Urbicus Ref: URB22-310
Primary Contact: Mark Clayton

Applicant response to Further Advice

Council reference: A006831322
Property details: 457 Adelaide Street, Brisbane City QLD 4000

Figure 1 – Adelaide Street Section

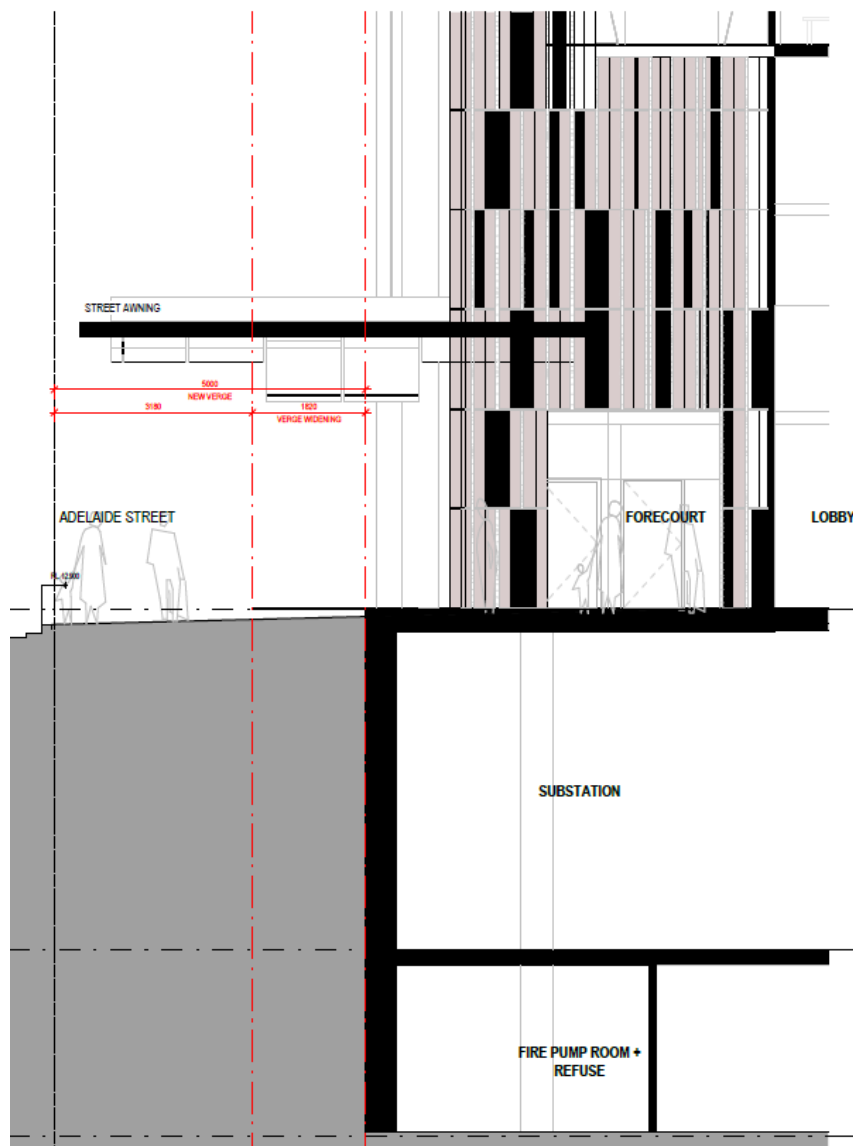
Item	Adelaide Street Verge Width and Setback
1	<p>It is acknowledged the submitted plans show the setback to Adelaide Street has been increased. However, the proposed setback is still not sufficient and the buildings placement does not allow for a minimum 5m wide verge to be achieved to Adelaide Street, with elements of the building above and below ground level projecting into this space.</p> <p>Council advises that it has not historically supported tower-level encroachments into the verge or road reserve. Such encroachments permanently limit future public domain flexibility and establish an undesirable precedent for private development within land intended to remain available for public use. While Council has, in limited and exceptional circumstances, supported limited basement encroachments, this has only occurred where a clear and robust planning justification has been demonstrated; and the encroachment delivers a demonstrable public benefit that cannot reasonably be achieved through alternative building design solutions.</p> <p>Based on Council’s assessment, it appears that the proposed encroachments are not necessary to achieve an acceptable built form outcome, noting the proposal is for a new building and no justification for the encroachment has been provided. The development could be reasonably accommodated entirely outside the 5m road reserve with minor design amendments, including modest internal reconfiguration and adjustments to balcony forms, without materially affecting design quality or residential amenity.</p> <p>To enable Council to continue its assessment, and to progress the application, please provide:</p> <ol style="list-style-type: none"> a) Amended plans which demonstrate an increase in the setback of the building, so that all levels are located outside of the required 5m verge width. Council could support the building being built to the new Adelaide Street front boundary where a 5m wide verge is achieved with no building encroachments at ground level or above. b) Where any aspect of the basement is still proposed to encroach into the 5m verge width, it must be clearly demonstrated why the encroachment is necessary and cannot be avoided through reasonable changes to the built form and design. From Council’s review of the plans, it appears the currently proposed basement encroachment only serves to provide access to the substation indicated on the Lower Mezzanine, although it appears that suitable access could be achieved without any basement encroachment. c) Should it be sought to retain any basement encroachment beneath the verge, Council advises that the following minimum requirements must be met: <ul style="list-style-type: none"> – A minimum clear height of 4.5m to the public thoroughfare easement, measured from finished ground level to the awning/building above; and – A minimum soil depth of 1.5m above the basement structure to support to delivery of infrastructure, landscaping and street tree planting.

Building setbacks to Adelaide Street above and below ground ensure the building is located outside of the required 5m verge width excluding the awning.

Refer to Drawings 12829_101, 102, 104, 105, 107, 301, 302 and 311 prepared by Nettletontribe and Figure 1.

Figure 2 - Fire pumps, diesel engines and fuel tanks.

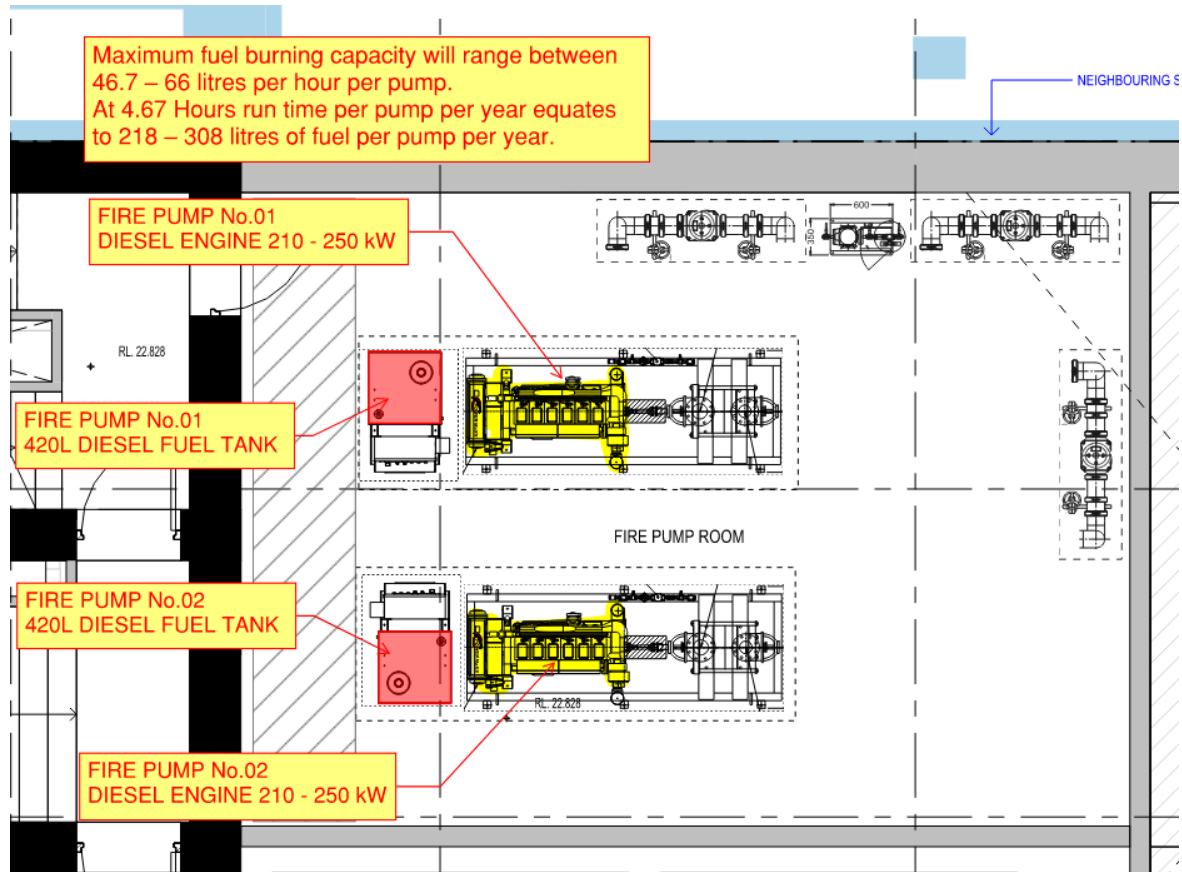
Item	Fuel Burning
6	<p>It is acknowledged that a condition has been requested to be set for maximum fuel burning. However given the constraints of this small site and the resultant floor plates, it is unclear how fuel burning could be provided in the future if it is not suitably considered now and any addition of fuel burning in the future would require a change to the development, regardless of a condition applied by Council now. It is therefore strongly recommended to:</p> <ul style="list-style-type: none"> a) Investigate and confirm the potential fuel burning / back-up generator requirements now. b) Clearly indicate the location of fuel burning / back-up generator on the plans to ensure that it can be accommodated within the building. c) Provide further information on maximum fuel burning capacity in MW; potential hours of use, type and quantity of fuel stored, air quality controls and type of engine.

Refer to letter dated 04/11/25 prepared by Firerite, detailing:

- Need for fire diesel pumps
- Diesel engines
- Maximum fuel burning capacity
- Air quality

Refer to Drawing No. 12829_108 Issue 11 prepared by Nettletontribe and Figures 2 & 3 below detailing location and example of fire pumps, diesel engines and fuel tanks.

Figure 4 – Building Section

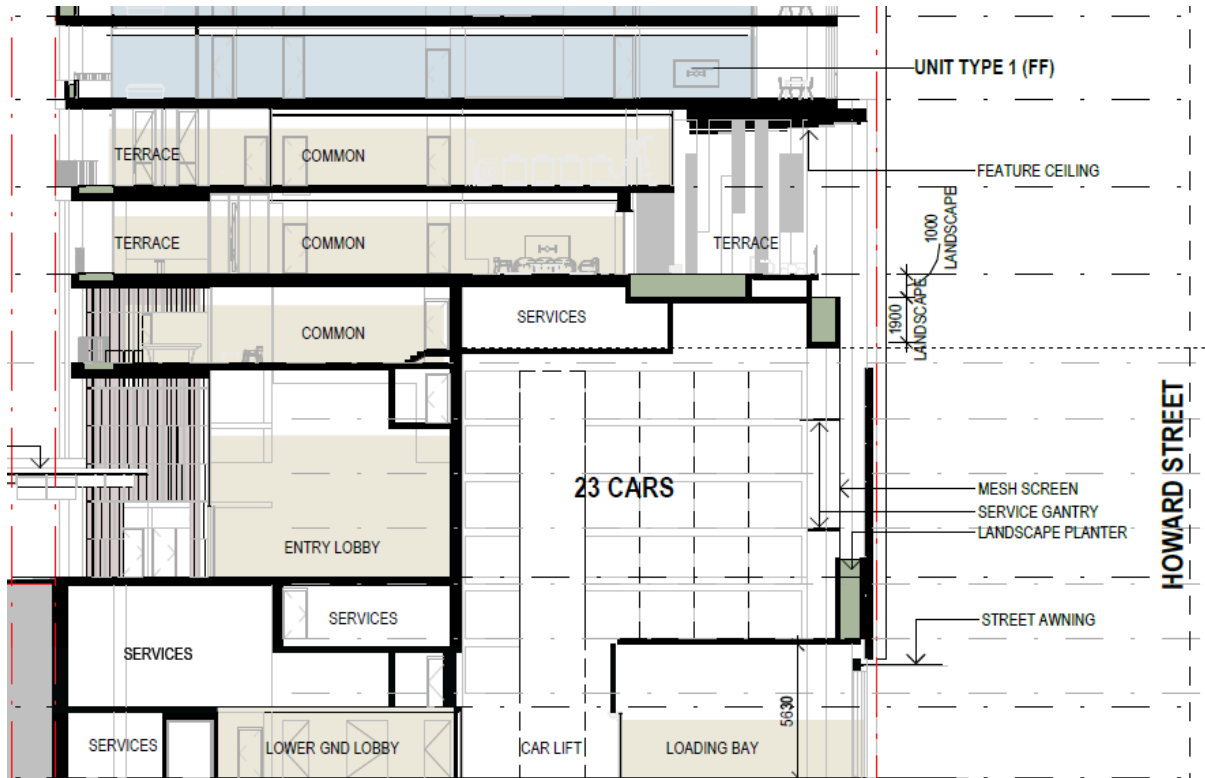
Item	Exhausts
7	The information response details that adequate separation from basement exhausts will be achieved, however insufficient detail has been provided to confirm this. Submit amended plans (particularly Sections Sheet 1, Drawing no.: 12829_301) to demonstrate that a minimum 15m separation distance is achieved from the basement exhaust points to onsite dwellings and their air intake points.

The basement carpark will not be mechanically ventilated and will not have exhaust vents.

The basement car park will be naturally ventilated through the roller door at ground level fronting Howard Street. The top of the roller door is separated more than 15m from the nearest on-site dwelling on Level 2. Refer to Drawing 12829_301 Issue 11 prepared by Nettletontribe and Figure 4.

The basement will not operate as a standard car park that accommodates multiple vehicle movements at any one point in time. The carpark will be an electronic controlled car stacker with only one car operational at any point in time while entering or exiting the car stacker. Cars will idle at the Howard Street entrance to the basement adjacent to the perforated roller door.
